Docket Item # 9 & 10
BAR CASE # 2012-0262 & 2012-0263

BAR Meeting
September 5, 2012

ISSUE: Partial Demolition/Capsulation; Certificate of Appropriateness for Alterations and Addition

LOCATION: 213 South Fairfax Street

1 SOUTH ELEVATION
A1.1 D2.3 1/8" = 1'-0"

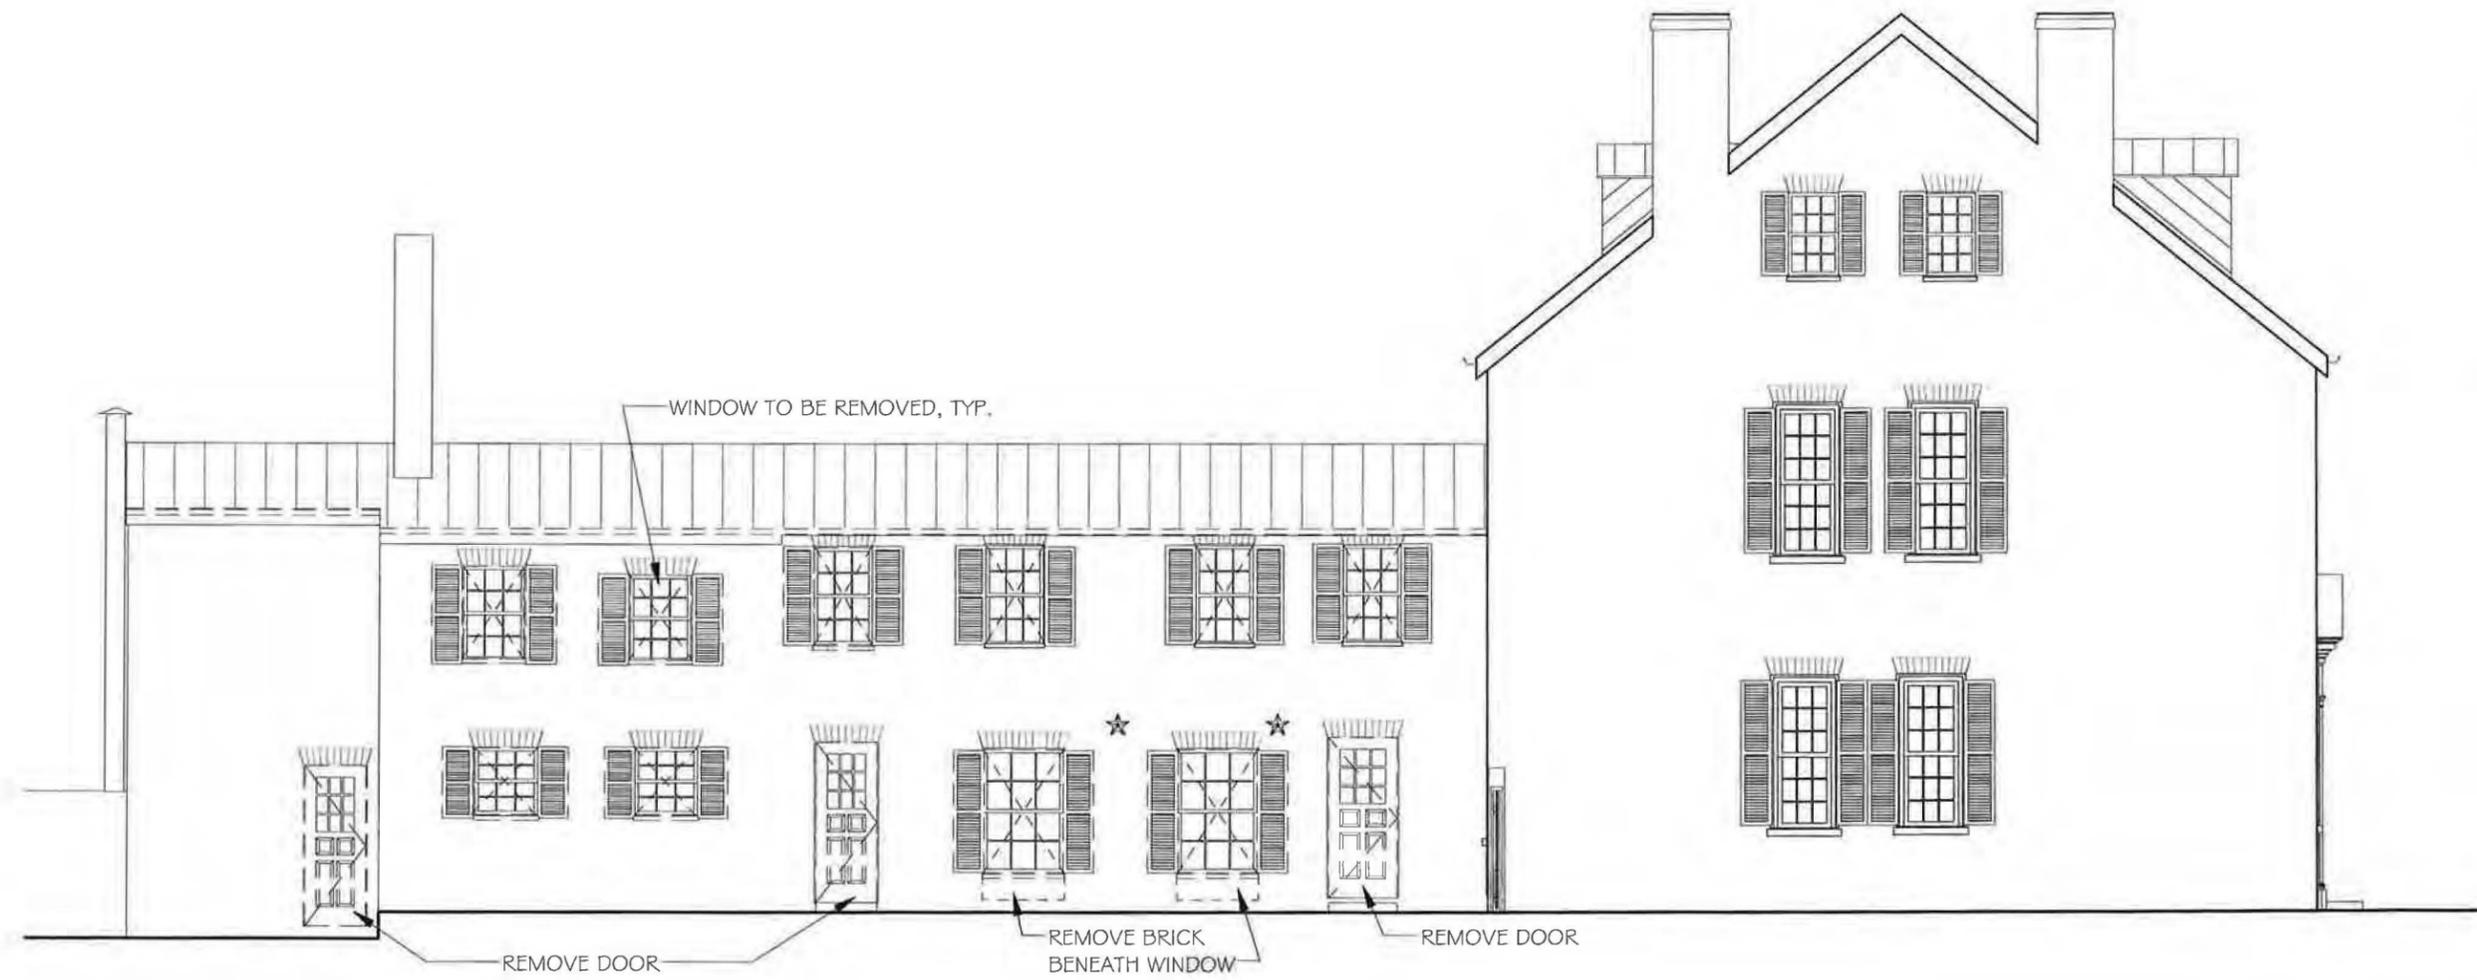
- Partially demolish (approx. 120 sq. ft.) and capsulate (approx. 656 sq. ft.) of wall area.
- Enclose the door opening on the first floor with recessed brick (approx. 1"). The door will retain its existing brick jack arch.
- Remove the existing six-over-six double-hung windows on the first floor and the brick beneath the windows in order to create openings for two, ten-light wood, French doors.

The proposed capsulation is to be located on a secondary elevation, is barely visible from a public ROW and most of the current exterior walls will remain intact. The Board generally supports additions which follow these practices. Staff has examined the windows proposed to be replaced on the ell and has found the existing sashes are modern replacements, many with aluminum jamb liners and nailed butt joints. Additionally, the two windows on the first floor proposed to be demolished were shortened in a previous kitchen renovation. Also, it appears that only one or two of the windows and doors still retain the original early-19th century beaded trim. Based on these findings, Staff does not object to the proposed full-frame replacement of the windows on the addition with SDL, painted wood windows with a 5/8” muntin.

1. That there will be no further demolition of the masonry walls, window openings or roof structure being capsulated as part of this addition unless reviewed and approved by the BAR.

1 SOUTH ELEVATION
 A1.1 | A2.3 1/8" = 1'-0"

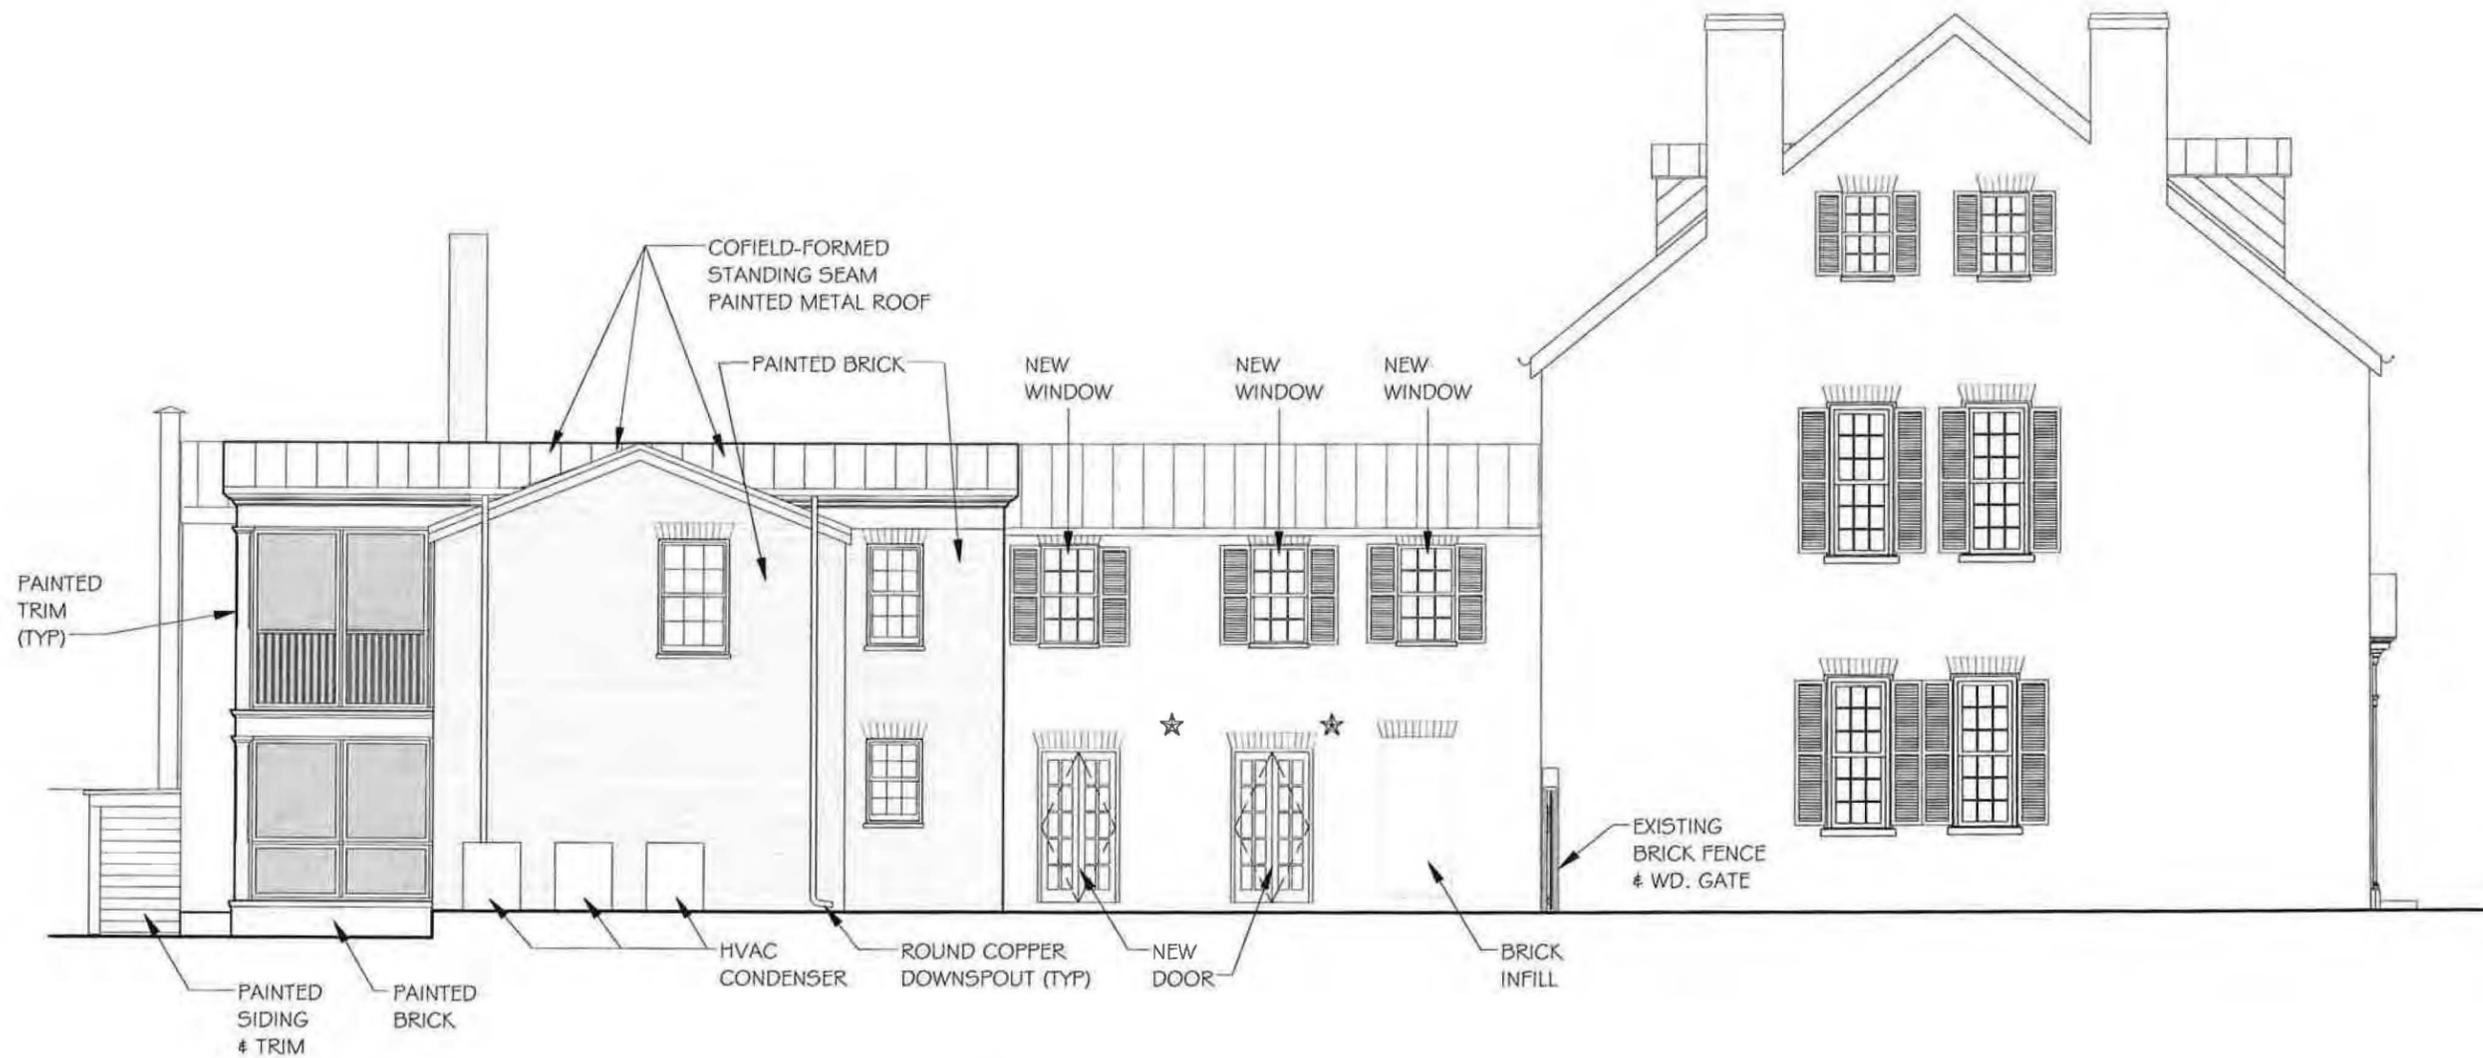
- Construct a two-story, painted brick addition (25' x 12'- 4 3/8"). The addition will contain a new kitchen on the first level and a bedroom/sewing room on the second. A two-story screen porch (9' x 12'- 4 3/8") will extend from the west (rear) elevation and will be constructed with painted, chamfered columns supporting a simple frieze. The east elevation will feature a set of French doors on the first floor and two, six-over-six SDL painted wood windows on the second. Both sets of openings will be capped with brick jack arches. The entire addition will be sheathed in a field-formed, painted standing-seam metal roof to match the existing historic massings.

- C-2 The proposed AC units are located in the required south side yard and do not comply with zoning.

2. That the design professionals and/or chimney contractors work with BAR staff to select appropriate and visually minimal chimney caps, damper/caps, or dampers to be installed on top of the existing chimneys.
